Project Name: The Falls Subdivision

Activity REZONE: RZ to PD-8 & OUTLINE DEV. PLAN

RE: C182-77, THE FALLS,
REZONE R-Z TO PD-8,
MESA COUNTY

Staff comments

Grading and Drainage

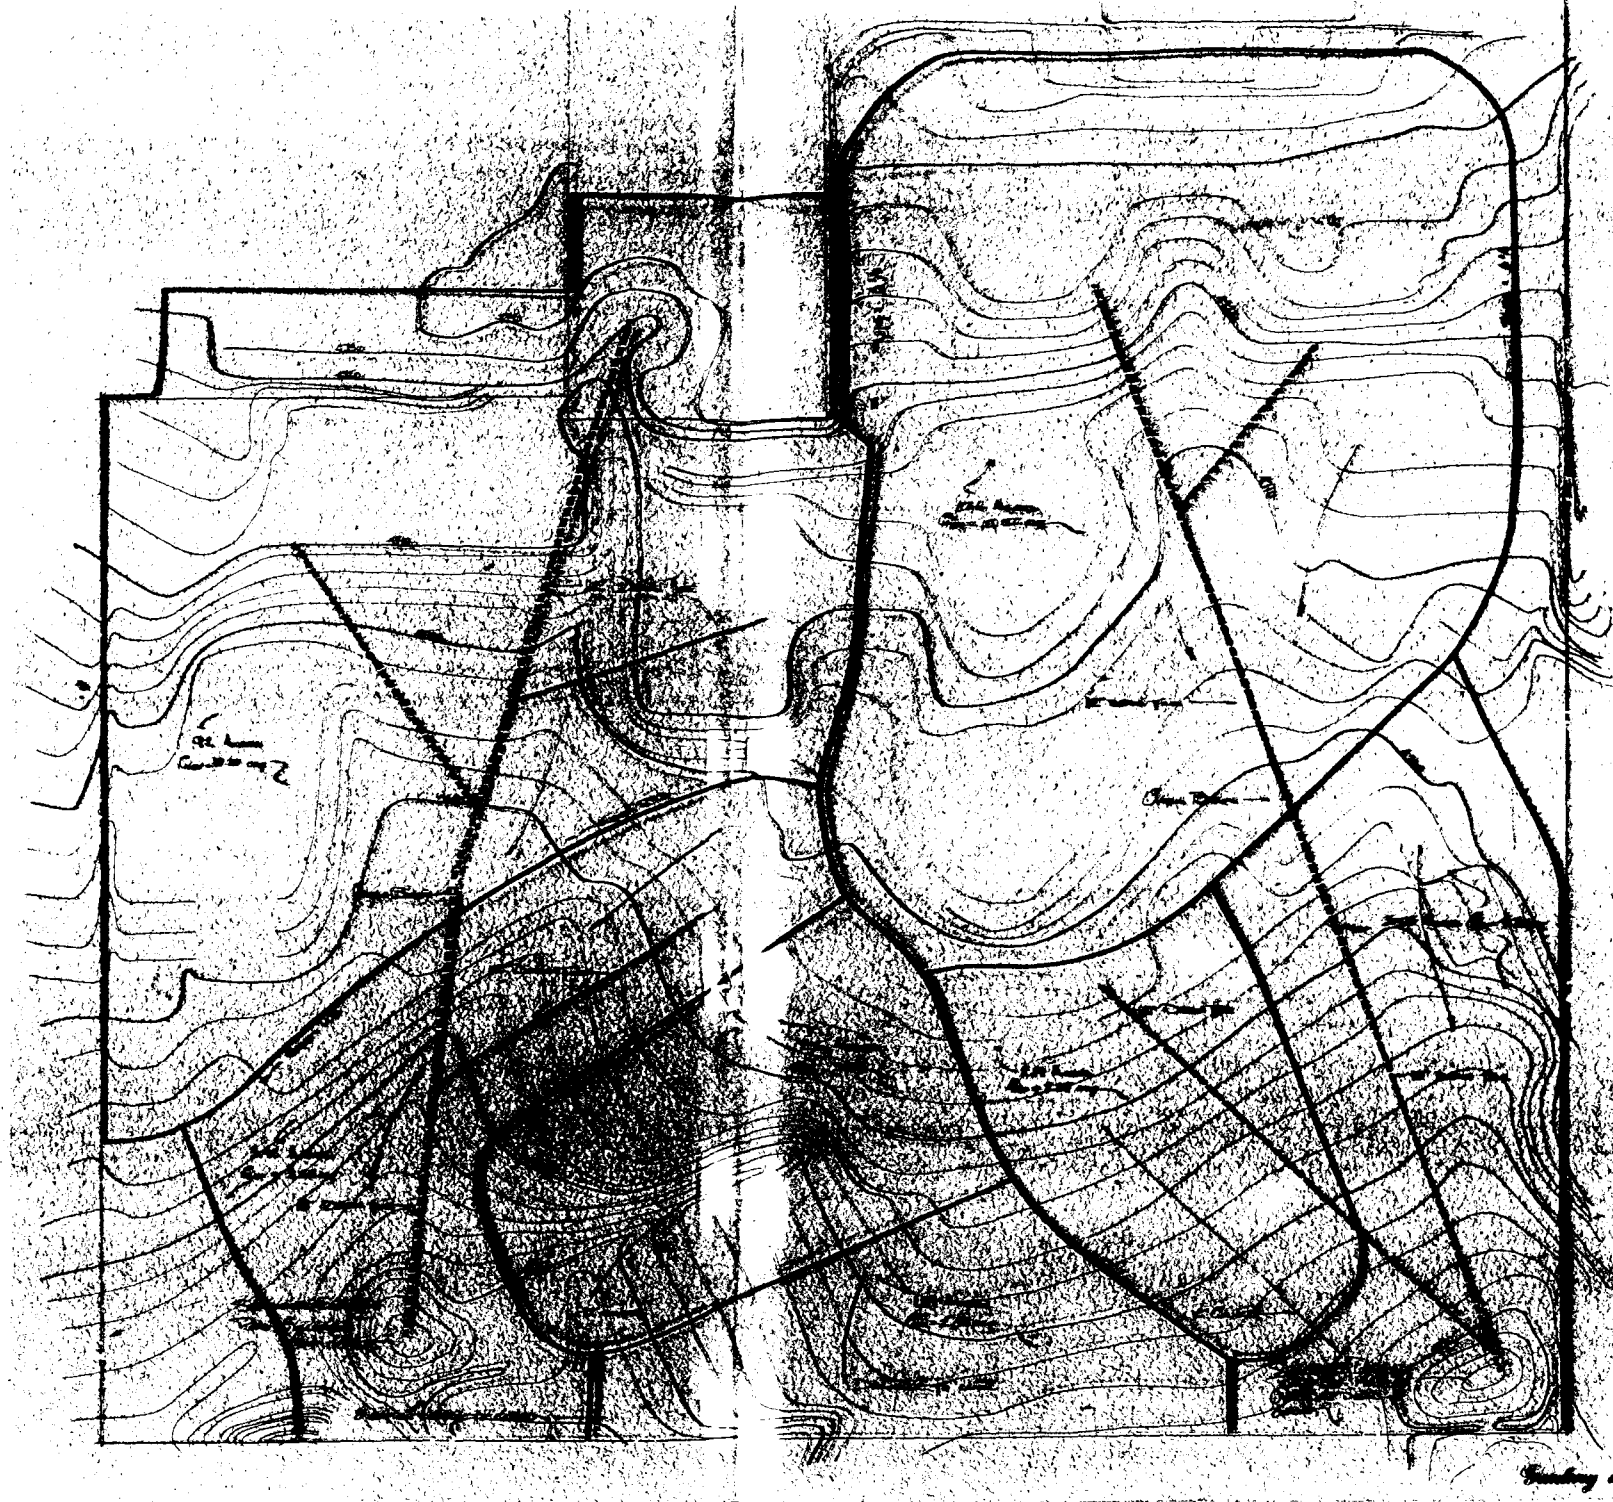
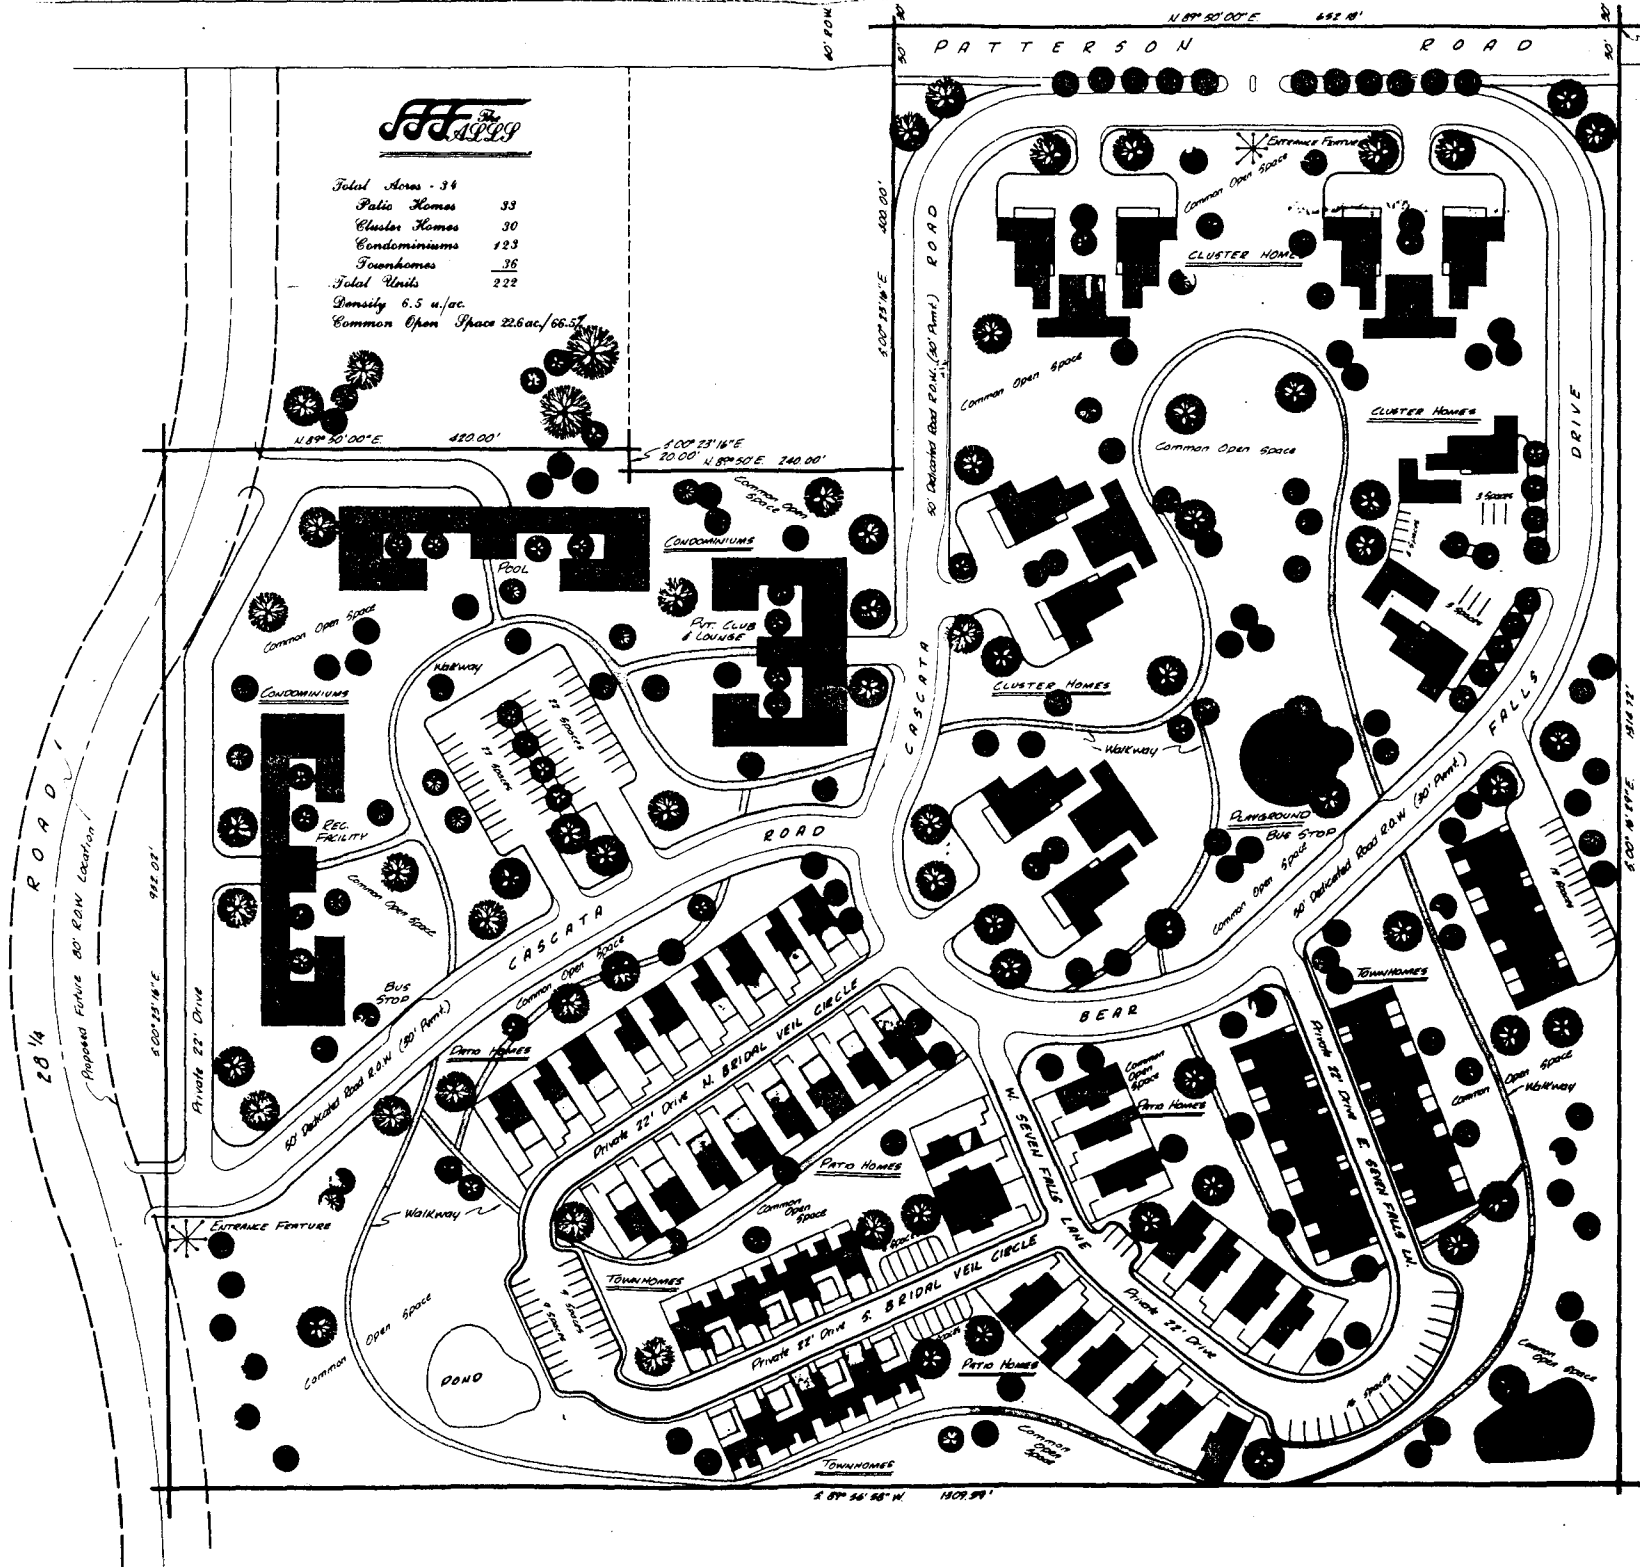
The grading and drainage plan shown in the outline development plan appears completely adequate at this time.

culverts & drainage pipes shown on overlay ^{objection? siltation?}

- they should be sized for at least 100 year storm where located beneath buildings

Limitations of the soil types present on this tract are severe for local roads and streets (high plasticity index, shrink-swell, depth to rock and slope), shallow excavations (shallow to consolidated shale, slope), and dwellings with basements (for the above reasons). It is the contention of the developer to fill in the precipitous valley areas and to smooth off the ridge tops - the plan is feasible from a soil standpoint but careful management of the fill areas must occur - Fills will compact over a period of time and it would be advisable to moisten the fill to increase the speed of natural subsidence - areas of fill that are to be built upon should be allowed a period of time for subsidence before construction commences. The areas to be filled will also create a drainage pattern not unlike the present if tiles or some other drainage system is not used to control the subsurface movement of water - there is no upslope runoff to speak of and water table build up should only occur from direct on site rainfall and resident watering - it would be advisable to engineer a drainage system that will insure protection from ponding and subsurface saturation - the grading and drainage plan shown in the outline development plan appears completely adequate at this time.
